- 2. Fritz Creek Drive No. 2 Sorensen; KPB File 2026-044
Mullikin Surveys / Sorensen
Location: Stuart Avenue & Sorensen Street
Fitz Creek Area**

**ITEM #2 - PRELIMINARY PLAT
FRITZ CREEK DRIVE SUBD NO 2 SORENSEN**

KPB File No.	2026-044
Plat Committee Meeting:	June 22, 2026
Applicant / Owner:	Albert E. Sorensen III of Homer, Alaska
Surveyor:	Christopher Mullikin; Mullikin Surveys, LLC
General Location:	Sorensen Street, Stuart Avenue, Fritz Creek area

Specific Request / Scope of Subdivision: The proposed plat will combine three lots of 1.826 acres, 1.841 acres, and 2.319 acres into one lot of 5.986 acres.

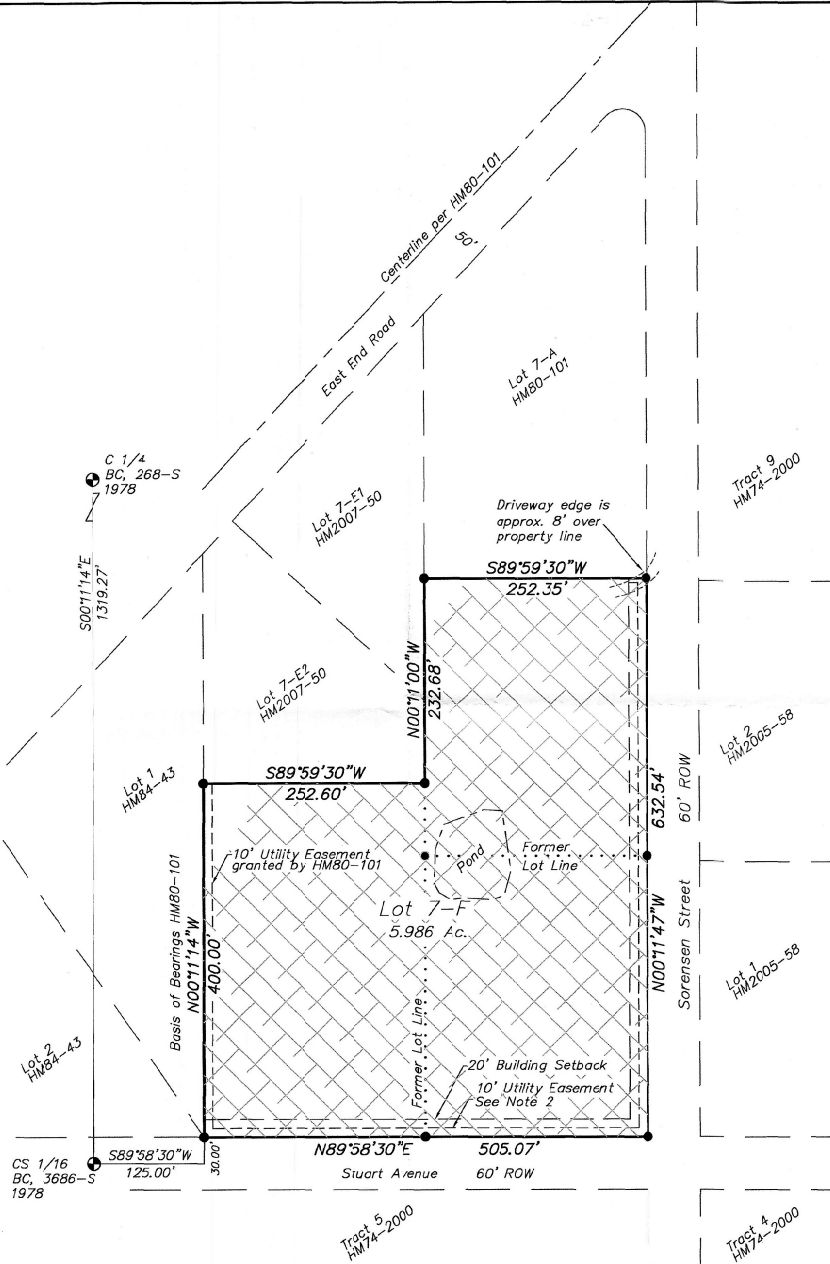
Plat note 2 states that there are 10-foot utility easement adjacent to the rights-of-way that increase to 20 feet within 5 feet of the side lot lines and includes the history of the utility easements. **Staff recommends** depicting the 20-foot within 5 feet of the side lot line easement along the west boundary.

- Modify the plat approval date to June 22, 2026.
- Within plat note 6, add a space between “wetland determination.”
- Change “Wastewater Certificate” to “Wastewater Disposal.”
- Identify which reference plat applies to dimensions given.
- C1/4 corner per HM80-101 and HM2007-50 has the year 1968 shown on it. Please correct.

- o Within the legal description, modify the subdivision name to be consistent with the parent plat "Fritz Creek Drive Subd. No. 2"
- o Modify KPB File No. to KPB 2026-044

- o Depict and label Stuart Avenue and Sorensen Street
